Docket Item #4
BAR CASE #2004-0280

BAR Meeting
July 27, 2005

ISSUE: New residential building

LOCATION: 804 Pendleton Street

Figure 2 - North

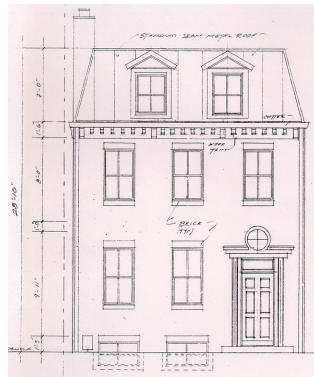
In general, Staff finds the revised design responsive to the concerns previously raised by the Board and the public. However, in the opinion of Staff a number of relatively minor issues remain and need to be addressed before formal approval by the Board.

Main roof: The mansard as shown has two different pitches from front to side planes. Adopting the shallower pitch to use on all planes of the mansard would diminish the overall mass of this portion of the roof. If the height can be reduced any more, it would be helpful as well. There is some ambiguity with respect to the roof material configuration, *ie* standing seam *vs.* batten seam joints. Without question the standing seam joint will have less presence and will present a finer scale when complete. The color of the mansard roof is a critical component of the "mass" question, as traditional Empire mansards were sheathed in slate, a relatively dark and hence, receding value. The color of the new metal roof should be dark, as opposed to light, in order to visually diminish the perceived mass.

Dormers: If retained, they should be reduced in size and detail to more appropriately fit the space and the scale relationships of the roof /wall relationship. The gable ridge should be well below the upper edge of the mansard and the overall width of the dormer structure should be reduced to a dimension substantially less than that of windows at the second level.

Figure 3 - West Elevation

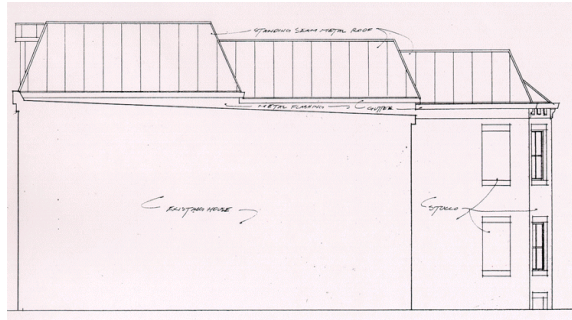
Stucco Scale: As shown, the use of recessed blind window openings on the west elevation of the

rear wing, and the east side of the main block is an effective and appropriate device for reducing perceived scale on these otherwise (code-required) blank wall expanses.
